**SUBJECT: COMMENTS ON TENTATIVE WASTE DISCHARGE REQUIREMENTS FOR THE
MOUNTAIN HOUSE COMMUNITY SERVICES DISTRICT**

COMMENTS
ON BEHALF OF THE
MOUNTAIN HOUSE COMMUNITY SERVICES DISTRICT
REGARDING
TENTATIVE WASTE DISCHARGE REQUIREMENTS
FOR
NPDES NO. CA0084271
Issued June 14, 2006

MOUNTAIN HOUSE COMMUNITY SERVICES DISTRICT
WASTEWATER TREATMENT FACILITY
SAN JOAQUIN COUNTY

**Proposed Relocation of Old River
Outfall and Modification of Old River
Monitoring Locations**

TITLE: EFFLUENT
 DIFFUSER
 PROFILES

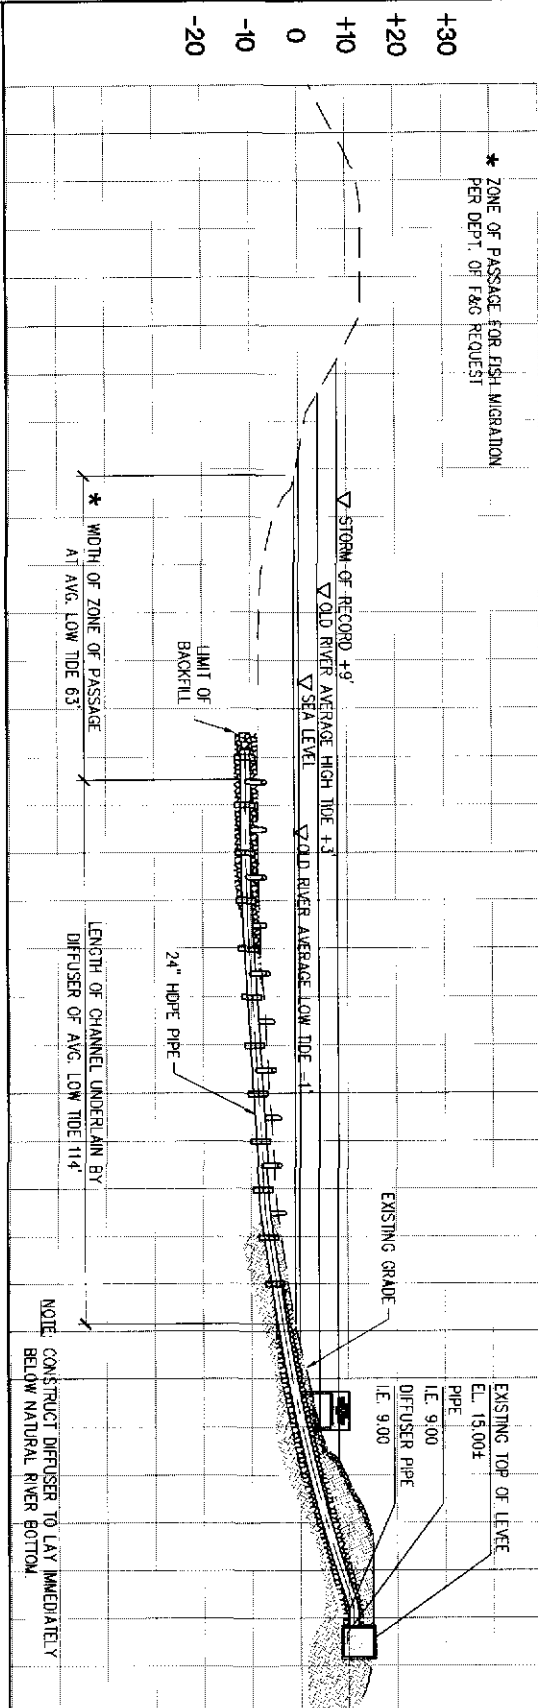
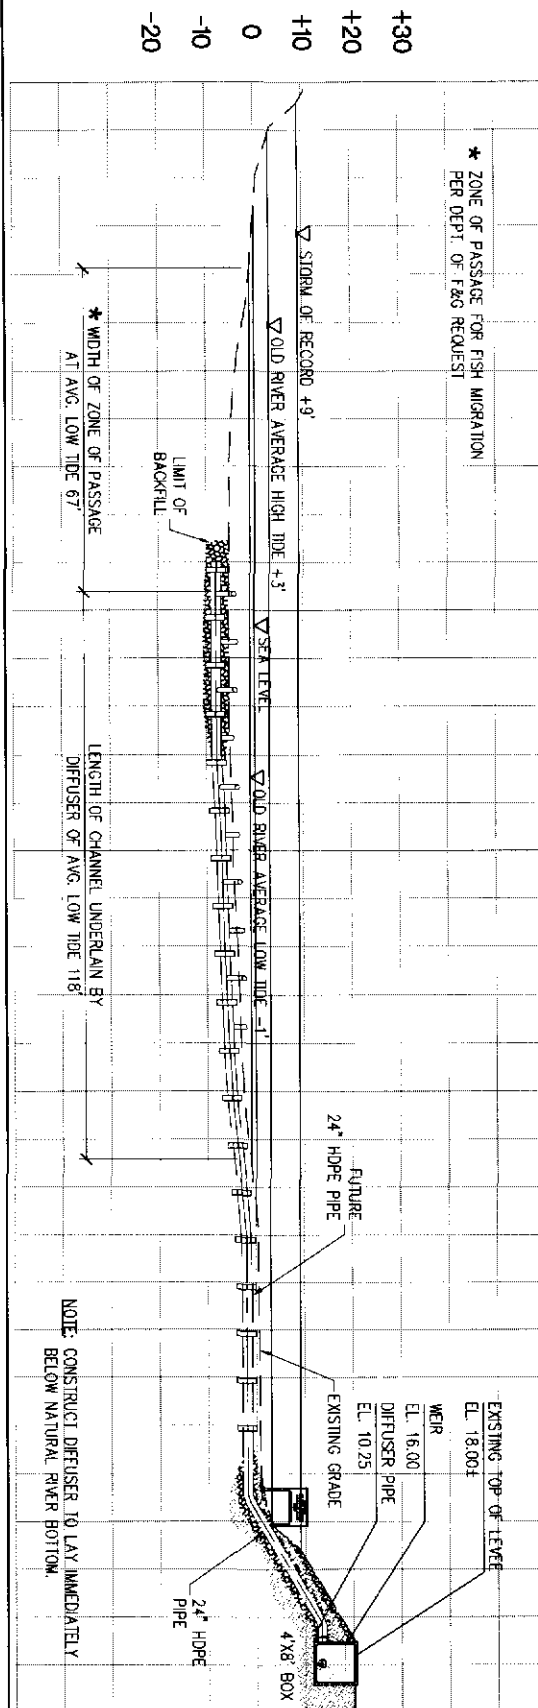
The 36-inch effluent pipeline portion from the first headbox (pipeline Sta. 25+25) to the permit outfall location must be constructed on top of the existing levy (3-ft. minimum burial) and consideration was given to whether or not it was necessary to convey the effluent the additional 2,900 feet or if the same mixing and impact on the Old River could be achieved by discharging at the first headbox approximately 300 feet downstream of the Wicklund Cut. Mixing, dilution and environmental influences of such a change are discussed below. For comparison purposes, attached Figure 01 includes a profile of the Old River and the effluent diffuser at this closer location, taken from the effluent pipeline construction drawings and identified as pipeline Station 25+25

Mountain House Community Services District would like to move the diffuser upstream in Old River about 0.8 miles, to just downstream of Wicklund Cut. There will be no expected changes in the near-field diffuser dilution, nor in the far-field tidal transport and mixing of the Mountain House WWTP effluent. The diffuser would be moved less than 1 mile upstream. The channel depth and width are very similar at these two locations, so the design of the diffuser would be identical. The near-field dilution and mixing patterns will be nearly identical for a diffuser located adjacent to Wicklund Cut as for the diffuser evaluated adjacent to Mountain House Creek.

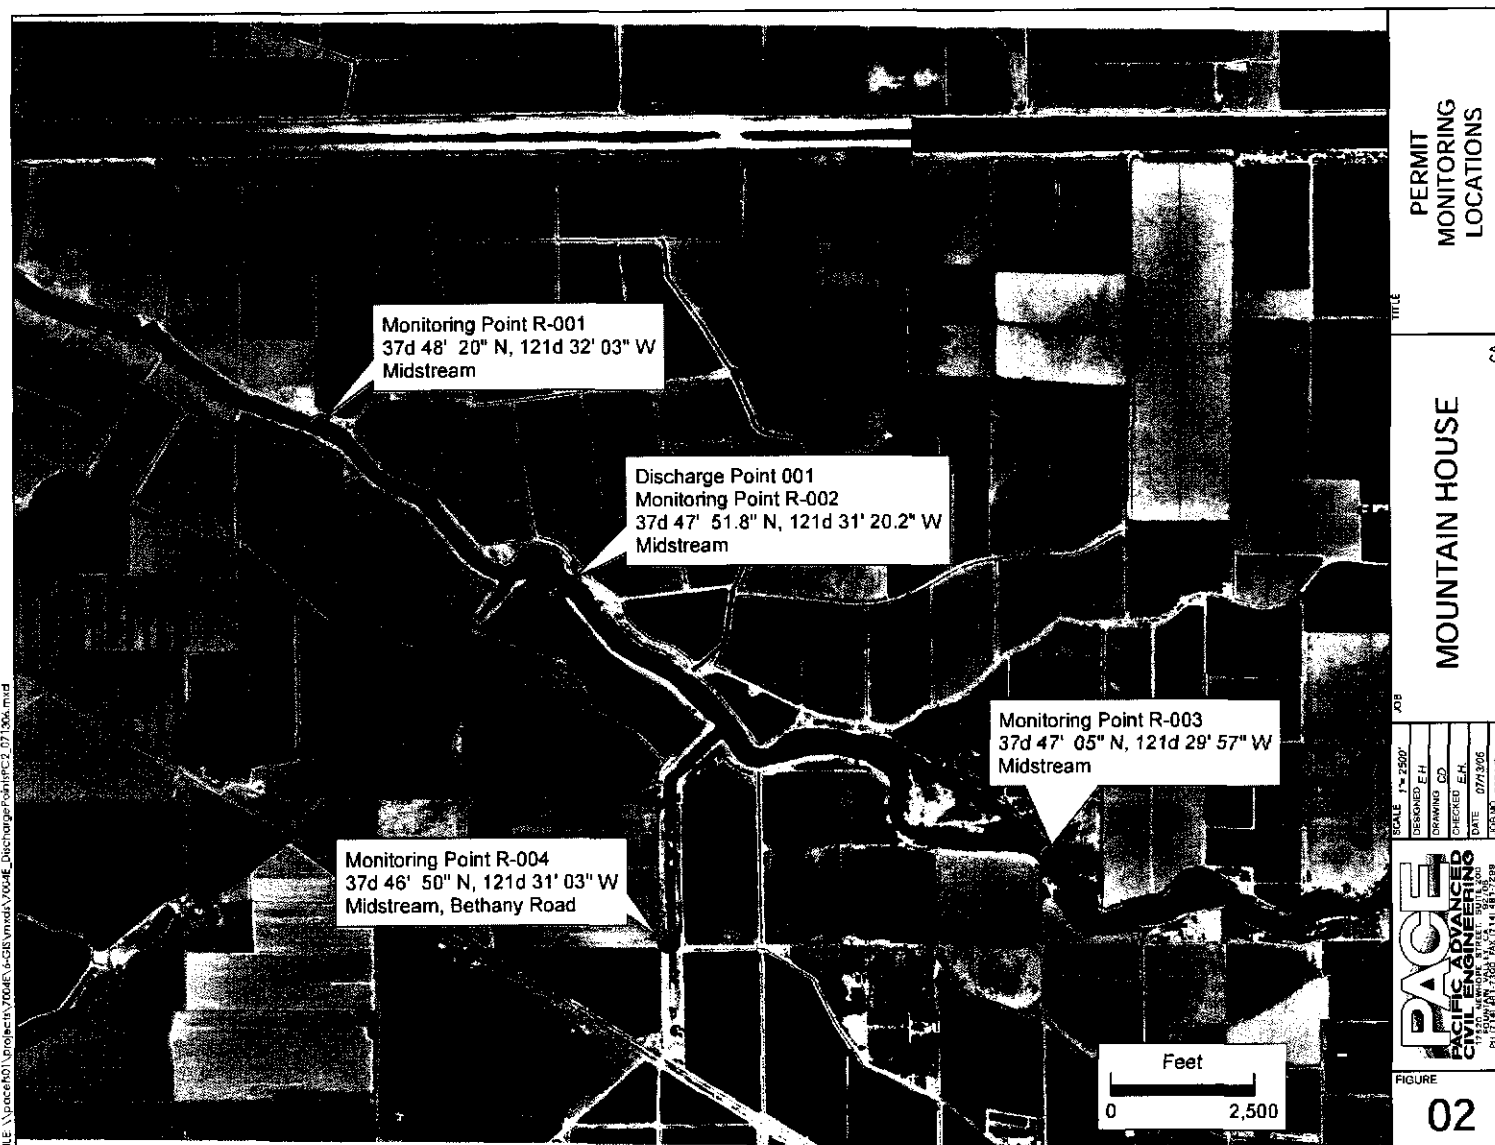
Old River monitoring points currently identified in the tentative WDR 's are shown aerially in attached Figure 02. They are identified as follows:

- R-001, approximately 500 feet downstream of permit outfall 001
- R-002, same as permit outfall 001 but at midstream
- R-003, approximately 1000 feet upstream of permit outfall 001 and 700 feet upstream of the Wicklund Cut confluence
- R-004, in the Wicklund Cut at Bethany Road near the water intake for the West side Irrigation District

- Move point R-003 upstream to a point 500 feet upstream of outfall 001 and just upstream of Wicklund Cut. This will make it consistent with R-001 which is 500 feet downstream of outfall 001
- Eliminate point R-004 as it does not serve as an upstream or downstream monitoring point for outfall 001. Should the West Side Irrigation District apply to use their water for municipal purposes in addition to irrigation, that will be required to monitor their intake water for parameters similar to those in the Mountain House WDR monitoring requirements.

- R-003 can remain where it is currently located in the tentative WDR 's.
- R-001 can be moved to a point approximately 500 feet downstream of the new outfall 001 location.
- Eliminate point R-004 for the same reasons stated above.
